#PIT5809: Clunk Pop Rattle Knock Click Type Noise Heard or Felt In The Steering - (Jan 27, 2021)

Subject: Clunk Pop Rattle Knock Click Type Noise Heard or Felt In The Steering

Brand:	Model:	Model Year:		VIN:		Engine:	Transmission:
		from	to	from	to		
Chevrolet	Silverado 2500/3500 HD	2020-2021		All	All	All	All
GMC	Sierra 2500/3500 HD	2020-2021		All	All	All	All

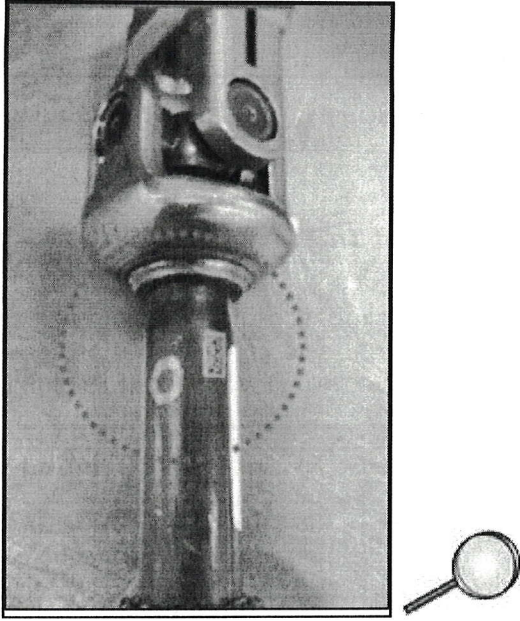
Involved Region or Country	North America
Condition	Some customers may comment on a clunk, pop, rattle, or knock type noise that can be heard or felt in the steering column. This concern may be more noticeable when turning at low speeds on rough road surfaces.
Cause	This concern could be caused by the steering column upper Intermediate shaft.

To correct this concern, replace the steering column upper Intermediate shaft with part number 84488136. Currently, this part number is still the old part number and a new part number will be released soon. To ensure you are getting the new updated Intermediate shaft, make sure it has the paint mark shown below. If the new intermediate shaft does not have the paint mark shown below, then it is not the updated version.
